MEMORANDUM

From: Service Manager Environment **To:** Head of Environment and Planning
Our Ref: EP/DC/PP/2016/0504 **Your Ref:** PF/P/2016/0504
Date: 15th September 2016

Location: O. S Grid Ref: 376 416 Land adjoining and east of Fairleigh, Station Road, Overton, Wrexham.

Development: Submission of Reserved Matters Pursuant To Outline Planning Permission Code No P/2014/0592 (Appearance, Layout, Scale And Landscaping) - Erection of 4 No. Detached Dwellings

Turning Areas

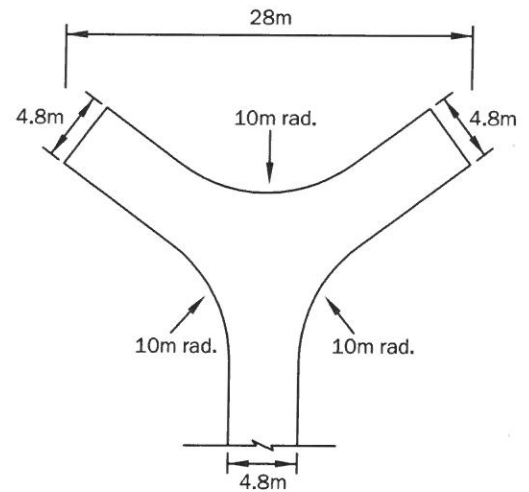
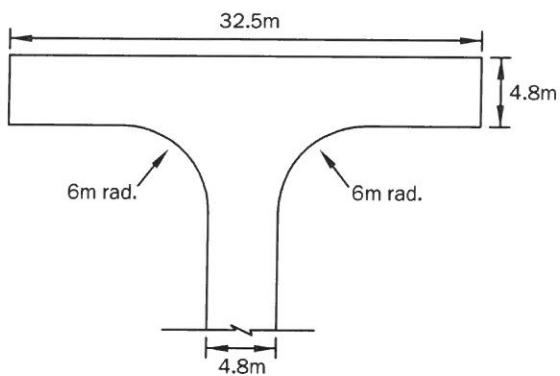
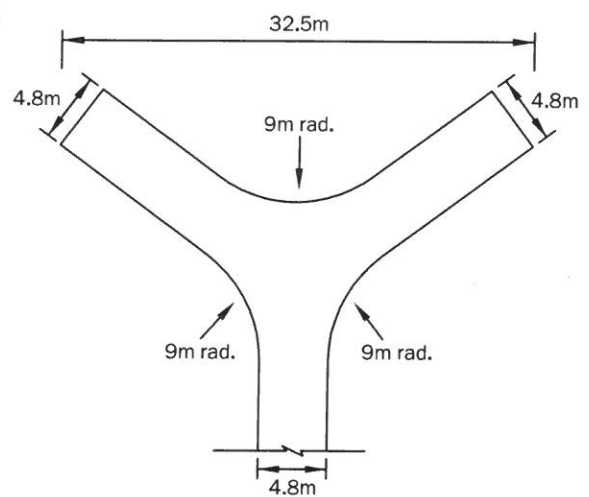
A turning head constructed to adoptable standards will need to be provided to serve the proposed development site. This will be required to facilitate the turning of refuse wagons / delivery vehicles within the curtilage of the site. A suitable turning head has not been demonstrated on the submitted layout plan. Details of a suitable turning head are attached. **Could you please ask the applicant to indicate the above detail on a revised layout plan.**

Turning areas are based on an 11.18m long, 2.55m wide refuse vehicle.

PARKING AND DRIVEWAY ARRANGEMENTS

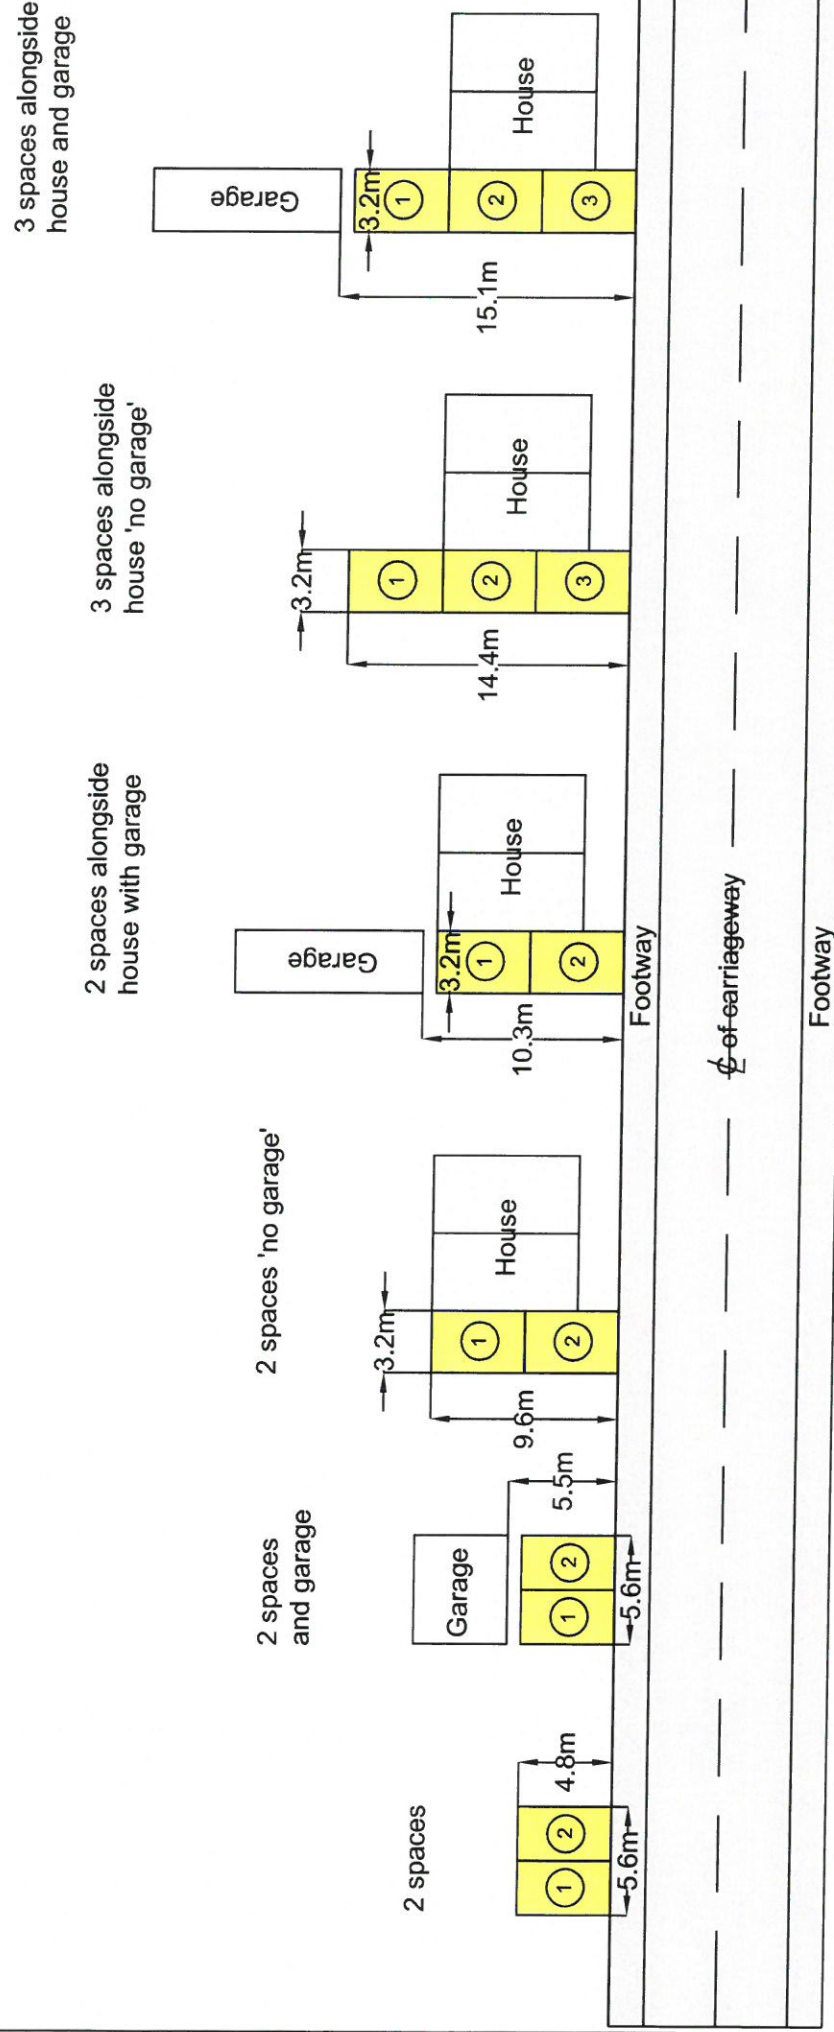
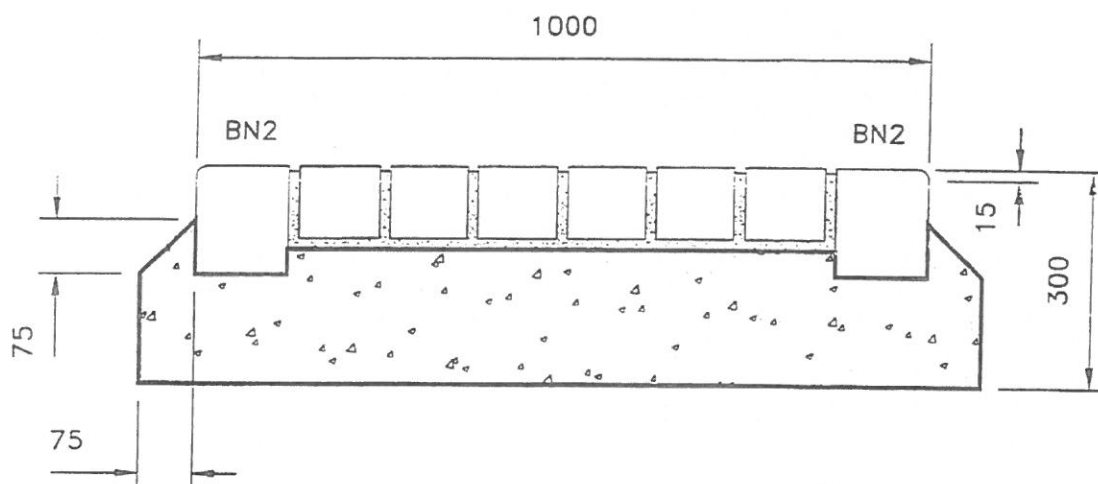
I would recommend that maximum parking provision is provided for each property in accordance with LPGN 16 requirements. This would require the provision of 3 spaces per dwelling (garage spaces excluded). The proposed driveways do not meet our standard requirements (see attached details). **Could you please ask the applicant to indicate the above detail on a revised layout plan.**

revisions	title	scale	date
	JUNCTION ACCESSWAY/ COLLECTOR ROAD	N.T.S.	12/94
		drawing no	11/01/07
		sheet	1 of 1

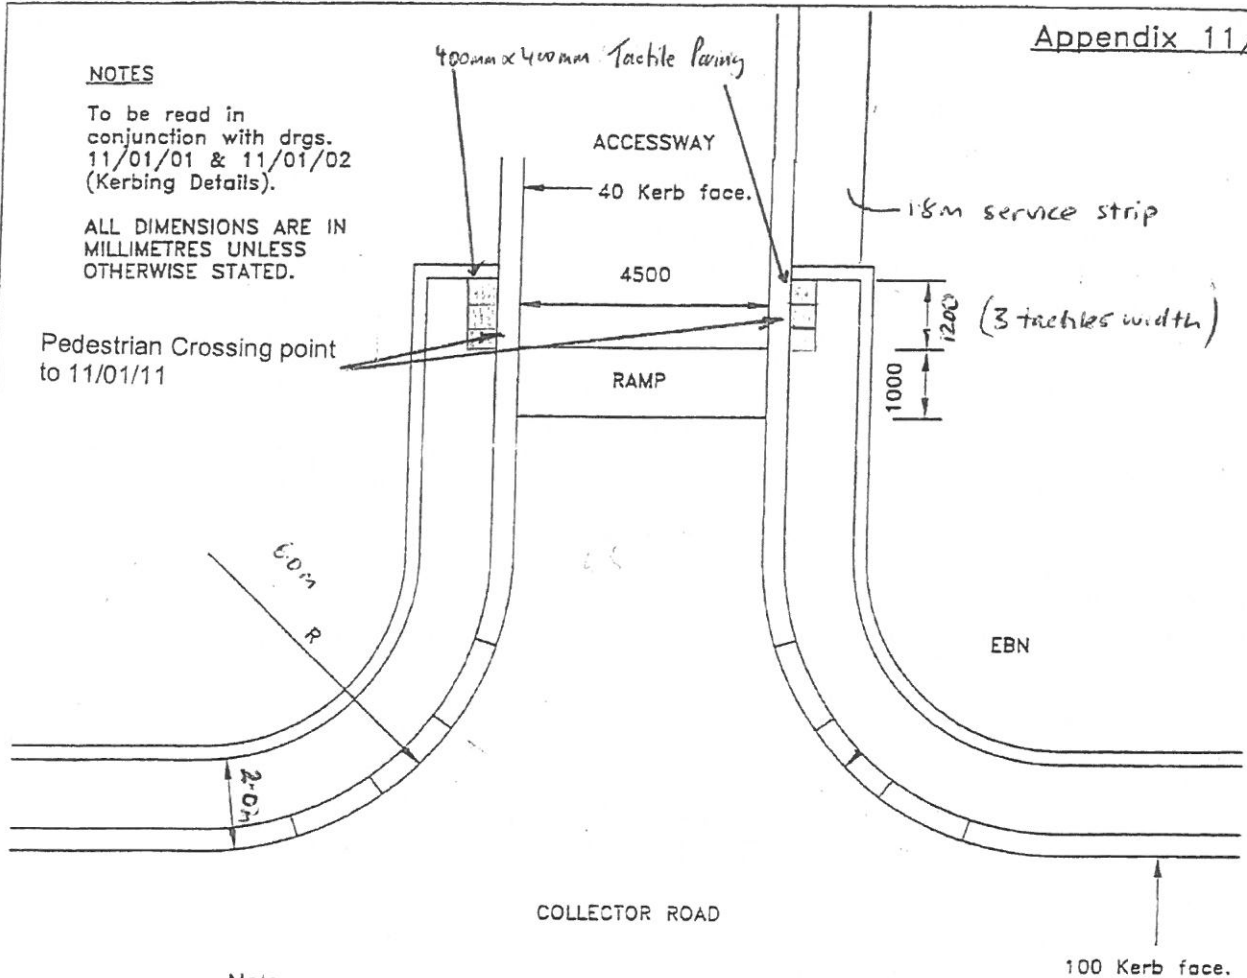
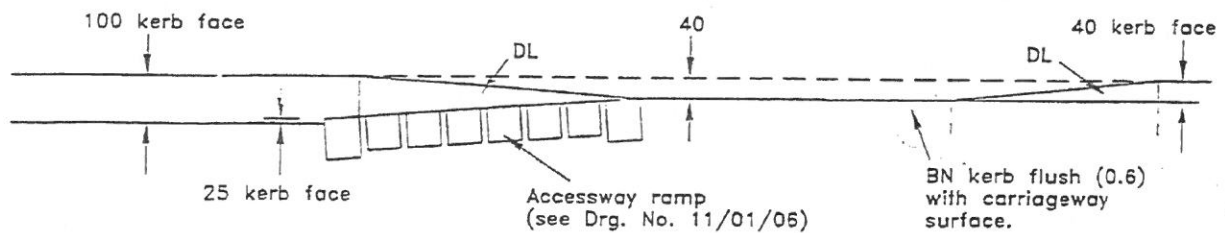
As the estate road has no footways (ie/ a shared surface) I would recommend the provision of 2.0m wide footways into the site just beyond the kerb radii incorporating a rumble strip / accessway ramp with appropriate dropped kerbs in the interests of pedestrian safety. **Could you please ask the applicant to indicate the above detail on a revised layout plan.**
